South Texas Project Electric Generating Station P.O. Box 289 Wadsworth, Texas 77483

May 06, 2002
NOC-AE-02001318
STI: 31440490
FILE NO: Z18
ER 20020035
10CFR50.4(b)(5)
10CFR50 App E

STP NUCLEAR OPERATING COMPANY
Units 1 and 2
Docket Nos. STN 50-498; STN 50-499
Changes to Emergency Plan Implementing Procedures

In accordance with 10CFR50.4(b)(5) and 10CFR50, Appendix E, Section V, the STP Nuclear Operating Company hereby submits the attached revisions to seven (7) Emergency Plan Implementing Procedures.

0ERP01-ZV-IN07	Rev. 7	Page 10 of 10
Offsite Protective Action Recommendations			
Addendum 5	Protective Response Zones		Page 1 of 1

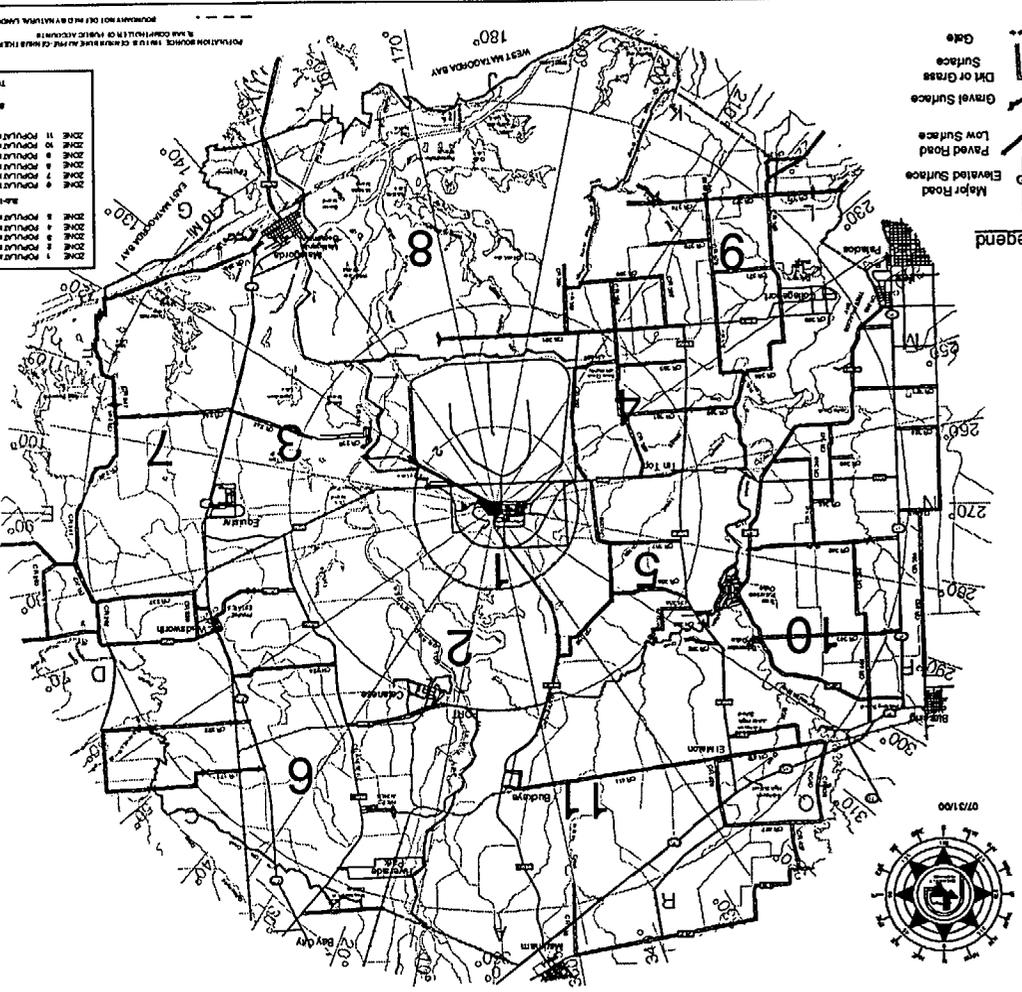
11	Addendum 4, changed 2-5 Miles to 2 Mile Radius & 5 Miles Downwind	Clarification
12	Addendum 4, changed 5-10 Miles to 5 Mile Radius & 10 Miles Downwind	Clarification
13	Data Sheet 1, page 10, after step 1.2, added a caution box, "Public Address Announcements may be changed or delayed due to the following conditions: Severe weather conditions which could threaten safe transport, a significant radiological hazard which could be encountered, a security threat occurring which could have an adverse impact on personnel moving	Reminds user the site announcement will start personnel moving around the protected area (CR 01-18674-1)

0ERP01-ZV-SH01	Rev. 16	Page 6 of 34
Shift Supervisor			
Addendum 1	Protective Action Recommendation Flowchart	Page 1 of 1

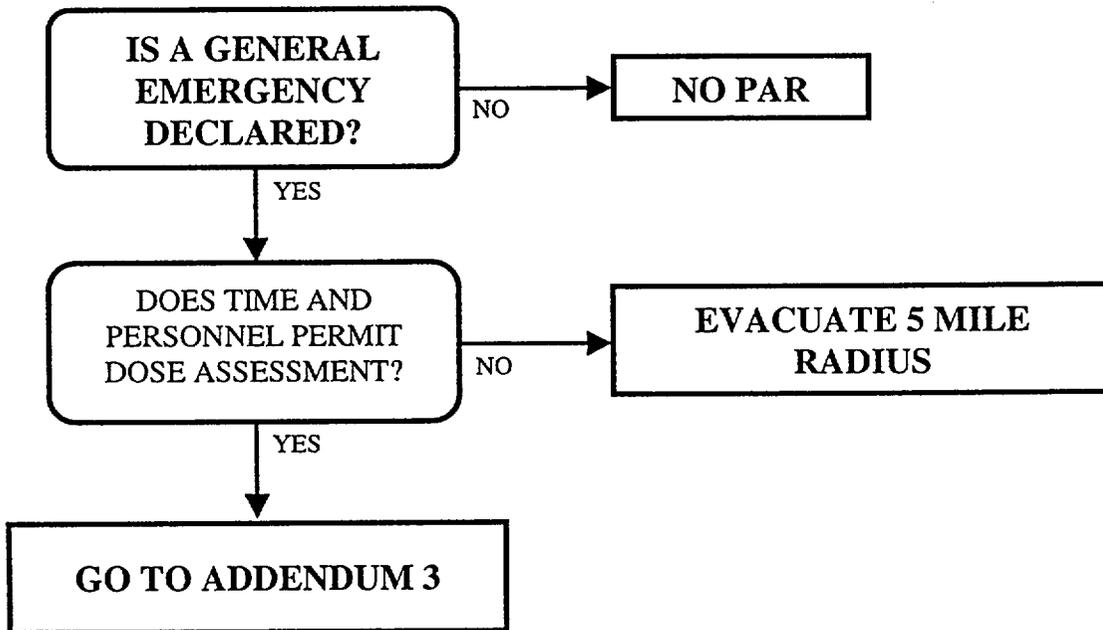
NO.	Change to Revision 15	Reason
1	Page 3, added step 3.14	Changed usage to N/A due to procedure OPGP05-ZV-0004, Emergency Plan Implementing Procedure Users Guide
2	Addendum 1, deleted Site Area Emergency PAR	There is no longer a PAR given during the SAE
3	Addendum 1, added entry requirement	Use Clarification
4	Addendum 1, added decision box for when PAGES are exceeded at 10 miles	Included as part of the PAR decision process
5	Addendum 1, removed core damage from flowchart	The SAE PAR has been deleted
6	Addendum 2, added entry requirement	Clarification
7	Addendum 2, revised table based on Health Physics evaluation	Request generated as a Drill comment
8	Addendum 2, added 5 and 10 miles downwind	Makes PARS similar to Addendum 3
9	Addendum 2, added note at bottom of page	Directs the user to assumptions used in PAR calculations
10	Addendum 3, removed reference to PAR during a SAE	There is no longer a PAR given during the SAE
